Department of Transportation

Subject: Staff Comments on North Stoughton Rd Design Alternatives, version 3.

Concept 1

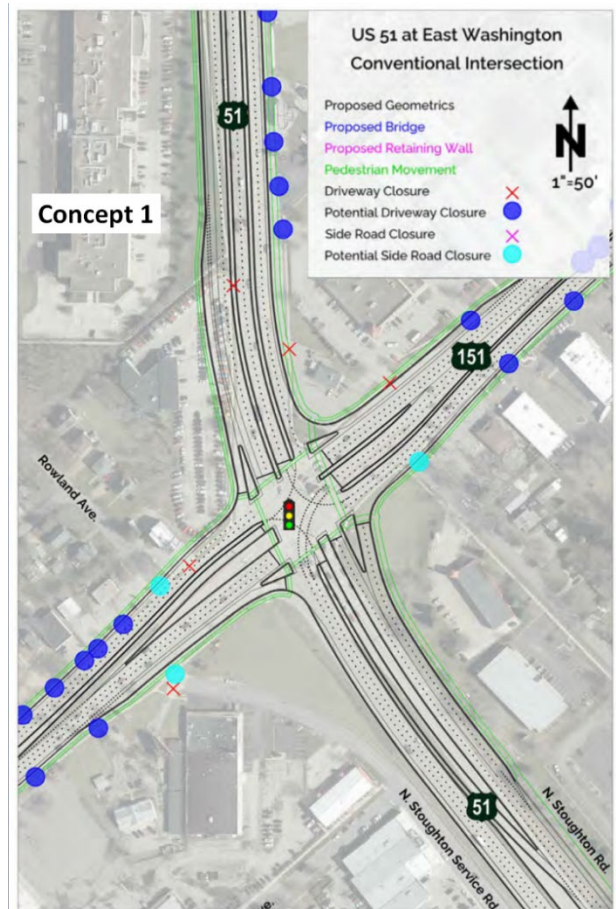
The existing Stoughton Rd and East Washington Ave intersection is poor with long crossing distances for pedestrians and bicycles. The proposed concept is similar to what exists with similar numbers of lanes. While poor, Concept 1's at-grade crossing is perhaps better and more urban than many of the concepts that have been presented.

This concept has relatively straight forward pedestrian and bicycle paths. Crossing distances are slightly longer due to increased island size. With the high volumes on both East Washington Ave and Stoughton Rd, it is important that pedestrians are able to cross each approach in a single phase, without having to use an island as a refuge. We encourage WisDOT to reconsider the need for the SBRT and EBRT slip lanes at East Washington & Stoughton Road. These slip lanes add complexity and delay to the pedestrian crossing.

We also encourage WisDOT to maintain some type of access between the North Stoughton Service Road and East Washington Ave.

The concept has up to three potential side road closures due to policy reasons. Because this access loss is policy rather than a geometric necessity, and these side road access have existed for decades as right-in/right-out driveways, staff recommend that these accesses be preserved.

This concept has numerous potential access removals, again for policy reasons rather than geometric. The loss of

these access points would result in numerous relocations and require that land remain vacant for lack of access. As with street access, staff recommend that these accesses be preserved as right-in/right-out.

As mentioned, if potential access closures occur it would result in numerous relocations. Staff recommend these accesses be preserved. This would allow both preservation of uses and future redevelopment in most quadrants of the intersection.

Concept 2

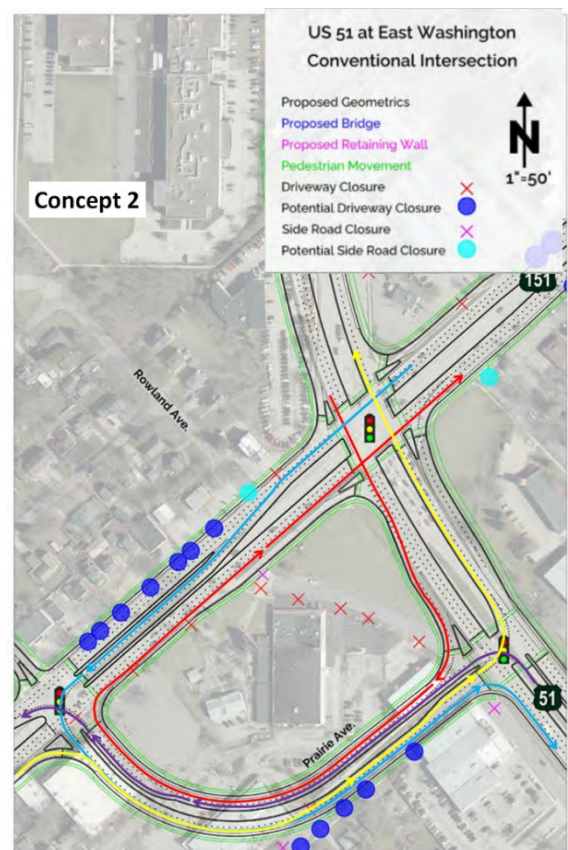
This concept, while adding one intersection to East Washington, reduces the size of the Stoughton Road/East Washington Ave intersection and keeps all movements at one level.

This concept has relatively straightforward pedestrian and bicycle paths. Crossing distances could be shorter due to reduced number of lanes that need to be crossed. We would encourage WisDOT to narrow the very large median islands that increase crossing distances and clearance times. While another intersection is added, the signal timing for both intersections would be more straightforward with fewer turning phases. As mentioned previously, with the high volumes on both East Washington Ave and Stoughton Rd, it is important that pedestrians are able to cross each approach in a single phase, without having to use an island as a refuge.

The concept has up to two potential side road closures due to policy reasons, and a realignment of the North Stoughton Rd Service Road. Because this access loss is policy rather than a geometric necessity, and these side road access have existed for decades as right-in/right-out driveways, staff recommend that these accesses be preserved. Staff also recommend access be allow on Prairie Ave, so that parcel would be available for redevelopment.

This concept has numerous potential access removals, again for policy reasons rather than geometric. As with the previous alternative, staff recommend that these accesses be preserved as right-in/right-out as they have currently existed for decades. It is important for access to be preserved on Prairie Ave so that land parcels on both sides are able to host active land uses.

As mentioned, if potential access closures occur it would result in numerous relocations. Staff recommend these accesses be preserved as right-in/right-out. It is likely portions of the shopping mall in the southwest quadrant could be relocated. It is important that this parcel maintain active uses through the preservation of some type of access. Because this intersection type does not have grade differentials that mandate access closure, there may be more opportunity for active land uses adjacent to the corridor.

Concept 3

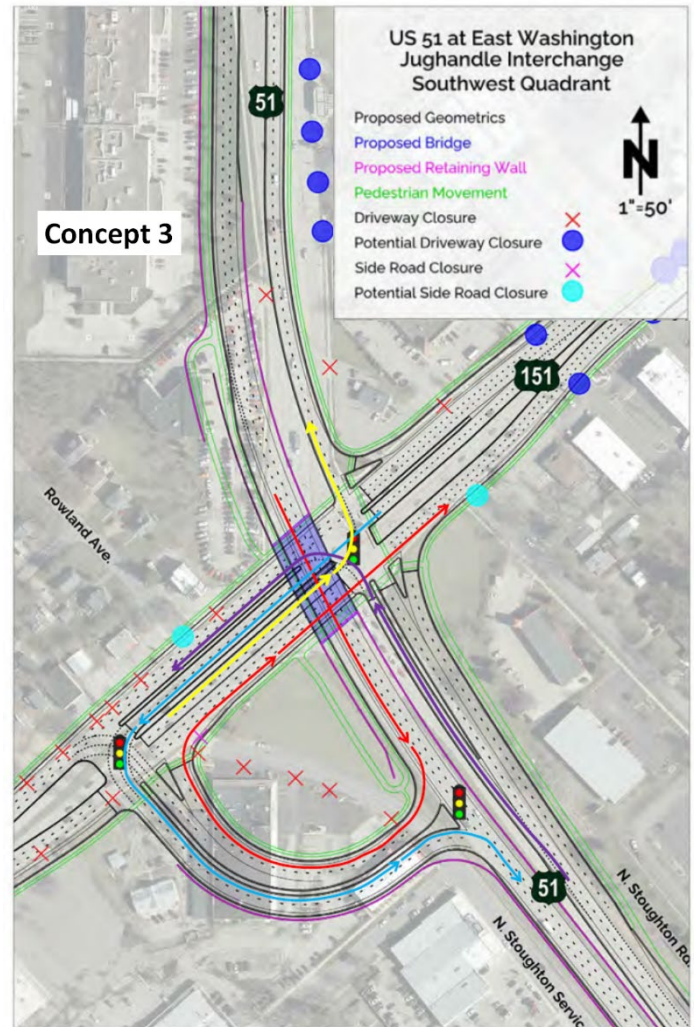
While grade separating one movement, this jughandle still incorporates signals in the northbound, southbound, eastbound and westbound directions. It adds intersection capacity without introducing a freeway interchange. This helps preserve urban speeds, and probably would not encourage speeding between up and downstream signalized intersections.

This concept reduces the number of lanes a pedestrian has to cross in the east-west direction by half, and eliminates many of the conflicting left turns from the signal timing. East-West pedestrian and bicycle routing is straightforward and direct. Extra efforts

are needed to provide pedestrian/bicycle connectivity in the north-south direction on the west side of the intersection. This includes, but is not limited to a signalized crossing on the west side of the jug handle intersection with East Washington. This was accomplished at Junction Rd/Mineral Point Rd through a spiraled path grade separation. The City of Madison recommends improving bike connectivity from neighborhoods south of East Washington to destinations and the Madison bike network north of East Washington.

The concept has up to two potential side road closures due to policy reasons. Again, staff recommends maintaining these sideroad access points as right-in/right-out.

This concept has numerous confirmed access removals. Some of these access removals are necessary due to grade changes, and the southwest quadrant ramp construction. Madison requests WisDOT re-evaluate the listed access removals in the westbound East Washington direction to see if all are necessary. These confirmed access removals would create a strip of relocations, and the ensuing vacant undevelopable land, that is not beneficial.

The access closures in the northeast quadrant would relocate Walgreens, an important area business. Since the grade separated lanes are in the southbound direction, there should be no additional grade challenges with providing access to Walgreens. Measures should be taken to preserve this access and business. Similarly, westbound East Washington Ave would have all accesses removed – resulting in a strip of relocations and corresponding vacant undevelopable land. Yet, there appears to be no great profile differential on East Washington Ave that would mandate these access closures. Staff recommend these accesses be preserved as right-in right-out to the extent possible. The southwest quadrant would be relocated, and there are no alternatives to this relocation. Yet, with the preservation of access, the northeast and southeast quadrants could remain active land uses. The southbound horizontal curve is designed so that it could relocate 3571 Stoughton Road. This building should be preserved.

Concept 4

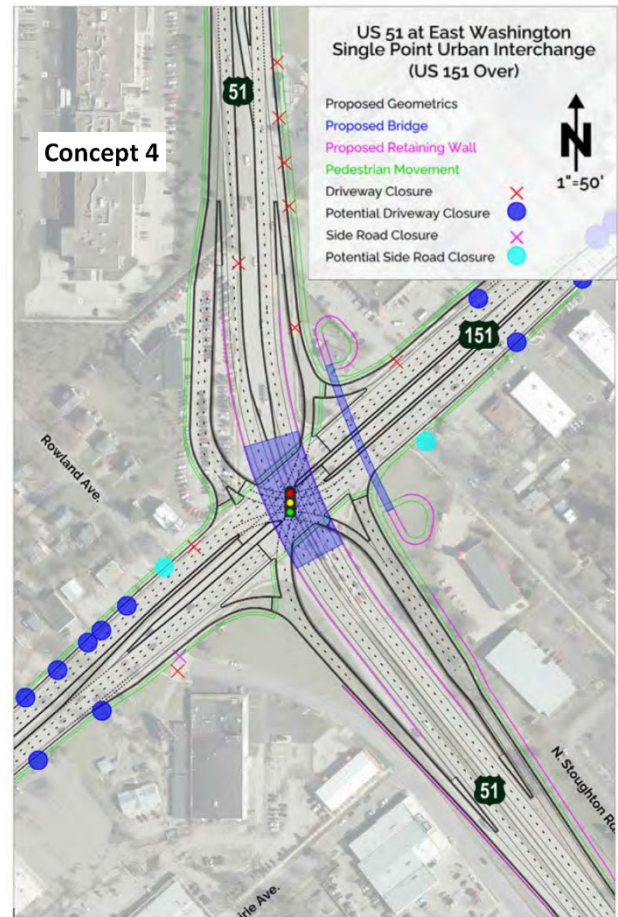
This concept is one of the more impactful concepts. It constructs a freeway interchange between two signalized intersections, which will likely create speeding problems in the urban street section to the north. Examples of where isolated interchanges pose similar challenges exist at Aberg and the at-grade intersections north of this interchange.

This concept technically reduces the number of lanes a pedestrian has to cross in the east-west direction, but there are multiple islands a pedestrian would have to travel through. Single Point Interchanges are very poor for crossings in the grade separated direction because there are no traffic gaps in the turning or through movements. Consequently, this movement must be handled through a grade separated pedestrian crossing. At the Verona Road Interchange, this is handled with a tunnel on the south approach. At the US 51/East Washington interchange, pedestrian crossing would be accommodated on the east approach through a spiraled ramp. No accommodations would be provided on the west approach. There is concern that some pedestrians would cross at-grade in the north-south direction to avoid the indirection of the pedestrian bridge on the east approach, and the total lack of north-south pedestrian accommodations on the west approach. Madison has had poor compliance/usage of the pedestrian bridge similar to this proposal crossing East Washington Ave at Marquette

Pedestrian crossings in the East – West direction would be broken into 4 separate crossings which would add substantial signal delay to the pedestrian crossing. Vulnerable users, such as the visually challenged or young bike riders, would have difficulty traveling through the interchange. The pedestrian crossings of some slip lanes shown may pose a hazard as people crossing on foot often disobey pedestrian signals when the crossing distance is short and delay high.

The concept has up to two potential side road closures due to policy reasons. Again, staff recommends maintaining these sideroad access points as right-in/right-out.

This concept has numerous confirmed access removals. Some of these access removals are necessary due to grade changes associated with the ramps. It is likely most entities in the northeast quadrant (Walgreens) would need relocation. Additionally, most businesses on the east side of Stoughton Rd and north of East Washington would lose access and be relocations.

For East Washington, Madison requests WisDOT evaluate the potential access removals in the westbound East Washington direction to see if all are necessary. If realized, these access removals would create a strip of relocations, and the ensuing vacant undevelopable land, that is not beneficial.

Unavoidable access closures in the northeast quadrant would relocate Walgreens, an important area business, and businesses north of Walgreens. Similarly, westbound East Washington Ave would likely have accesses removed because of their proximity to a freeway ramp terminal. This would result in a strip of relocations and corresponding vacant undevelopable land. Staff recommend these accesses be preserved as right-in right-out to the extent possible.

Note: If WisDOT feels that some type of interchange alternative must be brought forward, an alternative to the Single Point Urban Interchange could be a tight diamond interchange with north-south being the dominant direction. Staff had previously provided negative comments to WisDOT regarding a tight diamond, but a tight diamond decreases complexity with pedestrian and bicycle routing.

Concept 5

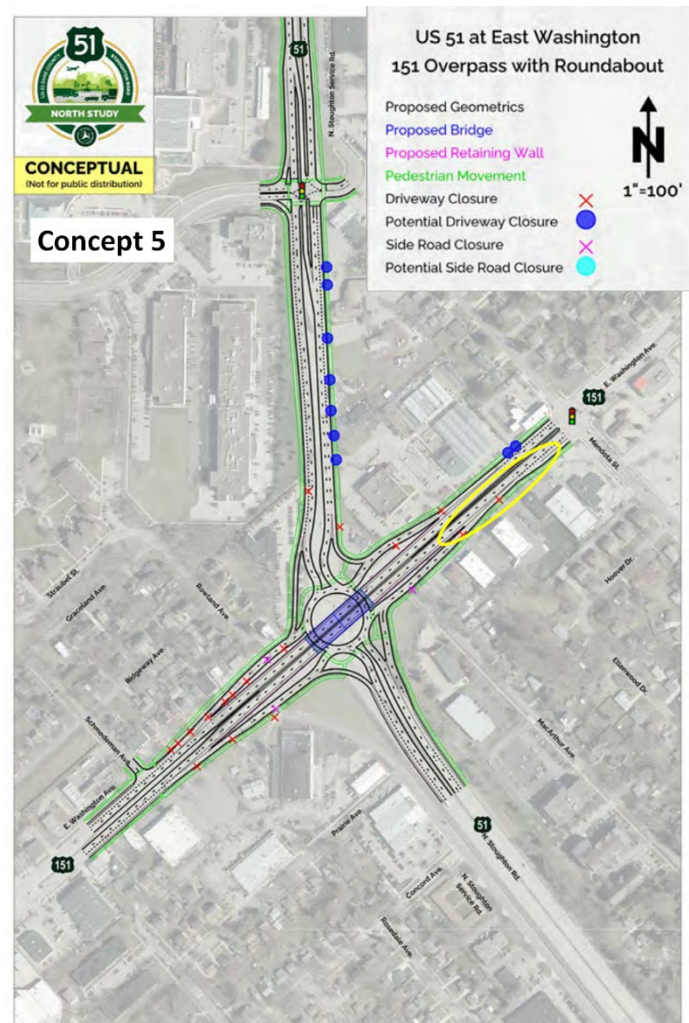
This concept is also one of the more impactful concepts. It constructs a somewhat unconventional interchange with the east-west direction being the dominant direction. The interchange is placed between two signalized intersections on East Washington Ave. This introduces a freeway treatment between two urban intersections. This could encourage speeding between signals on East Washington.

Concept 5 has pedestrians and cyclists cross the intersection at the depressed roundabout level. Pedestrian crossings at roundabouts tend to be indirect, and the roundabout bypass lanes in the intersection accentuate this challenge. North-south crossings would have fewer vehicles and more traffic gaps to cross. East-west pedestrians would have to cross larger traffic volumes without the aid of a traffic signal. Bicycle traffic would have very indirect routing through the interchange unless they chose to take a lane. Because of the bypass lanes, a cyclist would likely need to stop and wait 4 times to travel east-west through the roundabout.

Madison requests WisDOT reconsider the need for slip lanes for the EBRT, SBRT, and WBRT directions. Some may be needed for truck turning radii, but the extent that they can be reduced or eliminated would reduce speeds.

The concept has three confirmed and unavoidable access street closures

This concept has numerous confirmed access removals. Some of these access removals are necessary due to grade changes associated with the ramps. It is likely most entities in the northeast quadrant (Walgreens) would need relocation. Additionally, most properties west of Stoughton Rd and north of East Washington would lose access and be relocations.

For East Washington, Madison requests WisDOT evaluate the potential access removals in the westbound East Washington direction to see if all are necessary. If realized, these access removals would create a strip of relocations, and the ensuing vacant undevelopable land, that is not beneficial.

Unavoidable access closures in the northeast quadrant would relocate Walgreens, an important area business, and businesses north of Walgreens. Similarly, westbound East Washington Ave would likely have accesses removed because of their proximity to a freeway ramp terminal. This would result in a strip of relocations and corresponding vacant undevelopable land. Staff recommend these accesses be preserved as right-in right-out to the extent possible.

Concept 7

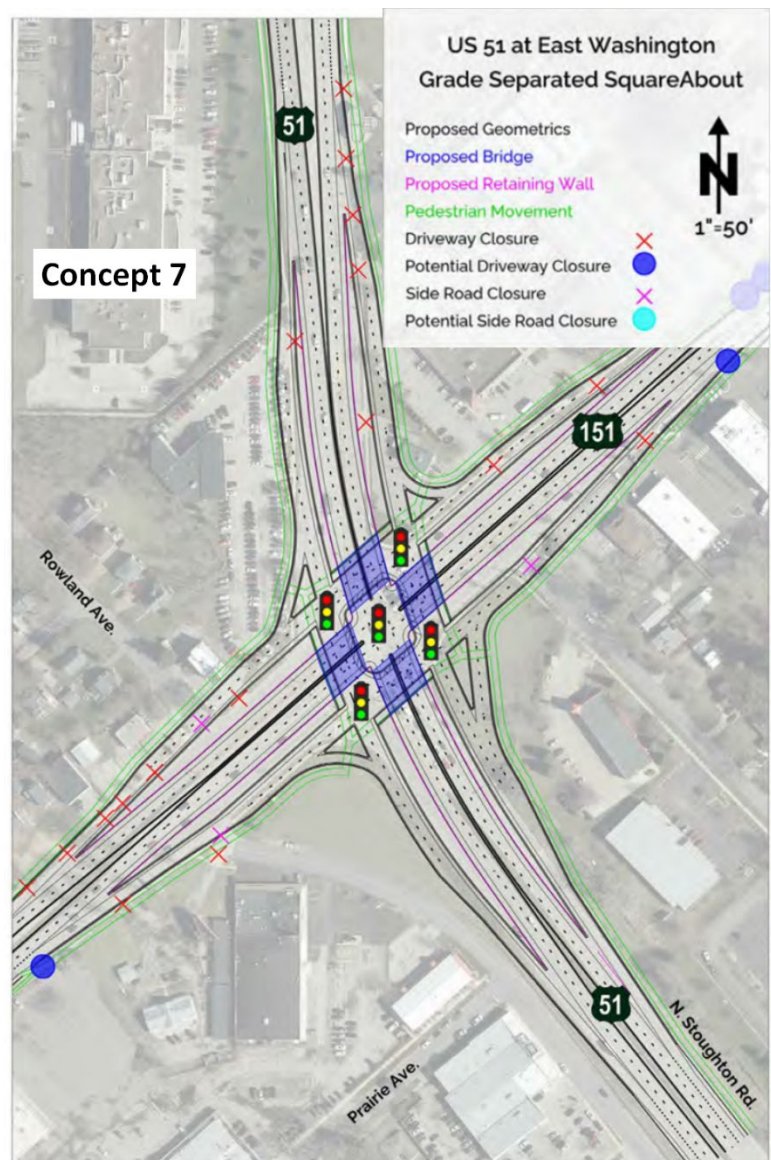
The benefits and impacts of this concept are very similar to Concept 6, except the signalized intersections for turning movements would provide simpler and more direct routes for pedestrians and bicycles. As mentioned with Concept 6, the signalized intersection for through movements could be unexpected for what appears to be an interchange and lead to more crashes.

This concept is also one of the more impactful concepts. It constructs a grade separated intersection between two signalized intersections on East Washington Ave. As mentioned, the signal for through movements would be unexpected, yet would be consistent with up and down stream signals on both East Washington and Stoughton Road.

Concept 7 has pedestrians and cyclists cross the intersection at the raised mini couplet level. The crossings are direct and straight forward, and the short-cycle signal timing would not create a lot of delay. Generally pedestrian crossing with this concept are better than those for Concept 6.

Because all through movements are removed and depressed, crossing travel volumes for pedestrians and cyclists are much more manageable.

The concept has three confirmed and unavoidable access street closures. Some type of connection (not shown) would be needed for the Stoughton Rd frontage road.

This concept has numerous confirmed access removals. Many of these access removals are necessary due to grade changes associated with the ramps. It is likely most entities in the northeast quadrant (Walgreens) and northwest quadrant (residences) would need relocation. Additionally, most businesses on the east side of Stoughton Rd and north of East Washington would lose access and be relocations.

Unavoidable access closures in the northeast quadrant would relocate Walgreens and businesses north of Walgreens. Similarly, westbound East Washington Ave would likely have accesses removed because of their proximity to a freeway ramp terminal. This would result in a strip of relocations and corresponding vacant undevelopable land. Staff recommend these accesses be preserved as right-in right-out to the extent possible. Grade changes and ramps would prevent access in almost all quadrants, relocating many businesses and preventing new development.

Lexington/Commercial Stoughton Road Intersection

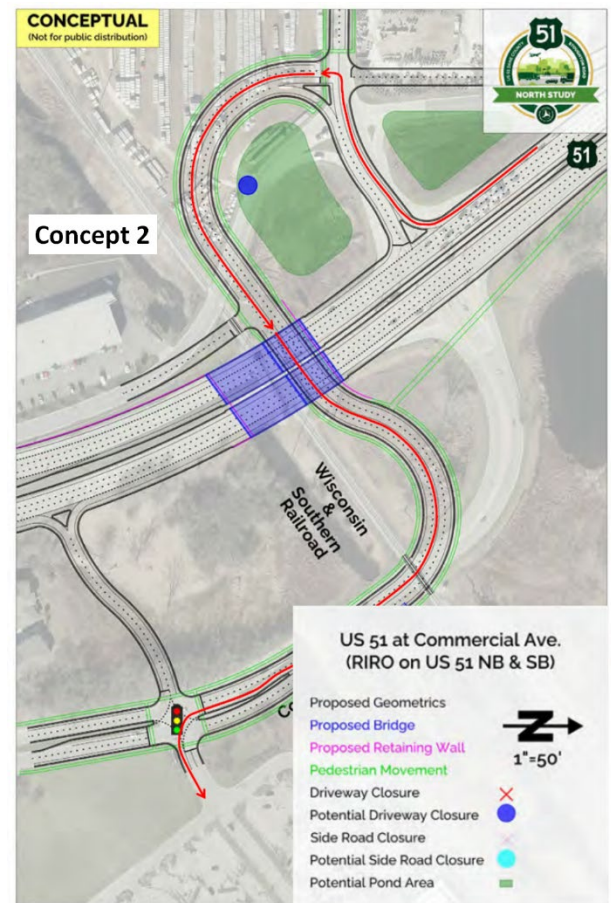
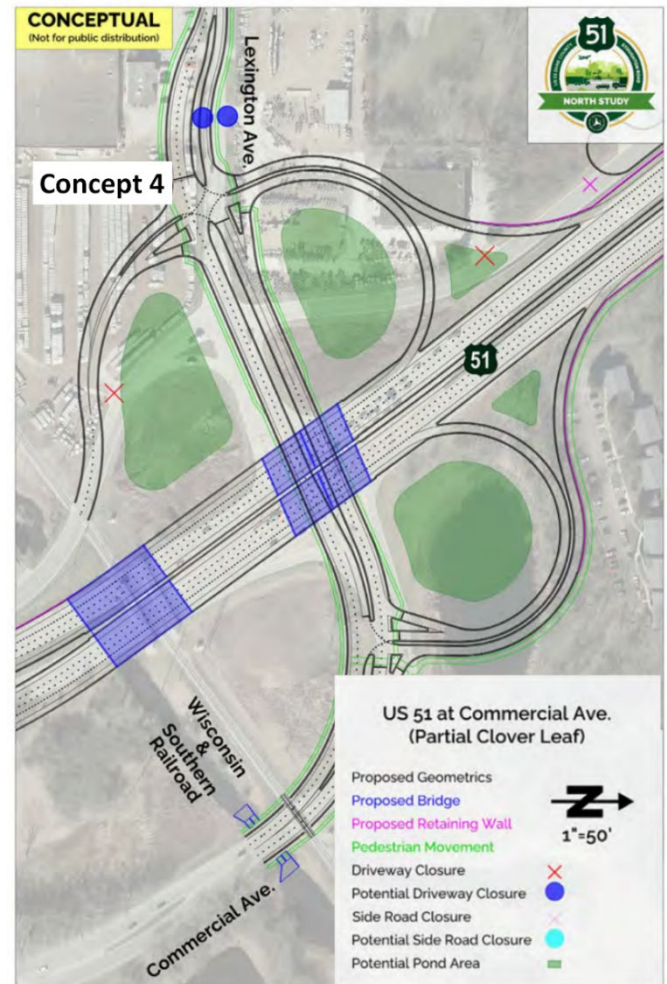
The realignment of the North Stoughton Service road provides very modest throat distance improvements for the impacts generated. Staff recommend revising this portion of the alternative.

Concept 4 places a freeflowing interchange ramps just 0.3 miles from the signalized Highway 30 ramp terminals, and 0.4 miles the signalized East Washington Ave intersection. The freeflowing ramps are contrary to the intersection control both up and down stream and could lead to higher speeds and more severe crashes. Concept 4 also requires two bridges and has greater right of way impacts. Therefore Concept 4 is not recommended.

Concepts 2 and 3 both provide a grade separated WSOR crossing, and therefore could provide benefits if passenger rail is brought to the Madison area. These alternatives also provide a less stressful crossing for pedestrians and cyclists. Staff have no strong preference between concepts.
